Product Change Notice (PCN)

PCN Number: PCN-0450726R-01

Product(s) Affected: PJ-002AH-SMT-TR, PJ-002BH-SMT-TR

Current version	New version
Outlook	 <p>housing</p>	 <p>housing</p>
	 <p>pin# 3</p>	 <p>pin# 3</p>

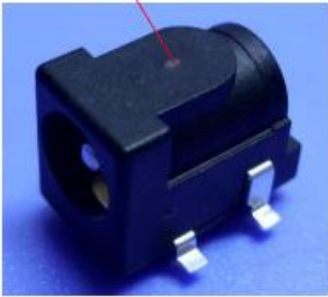
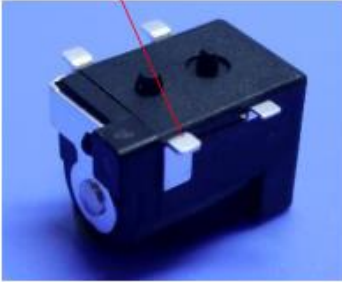
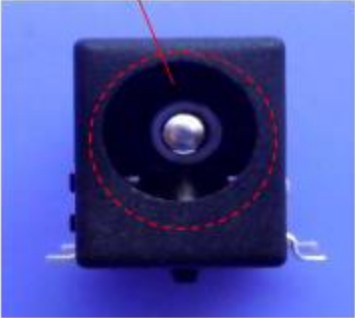
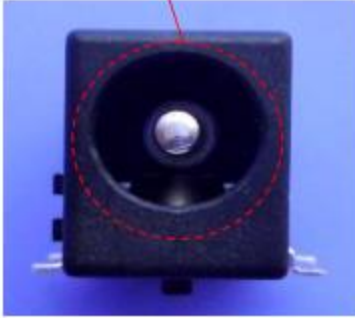
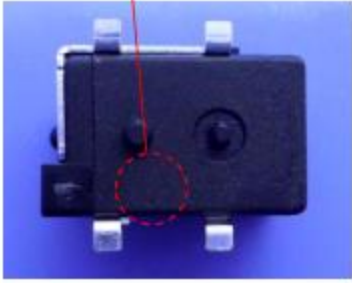
Reason(s) for Change: existing plastic housing and pin 3 molds cannot maintain efficient production.

Description of Change: to ensure quality and production efficiency, new mold development is in process. Aesthetic changes as shown below. Electrical structure and function remain unchanged.

Front	<p>jack hole without chamfer</p> 	<p>jack hole with chamfer</p> 
Bottom	<p>without cave marking</p> 	<p>cave marking location</p>
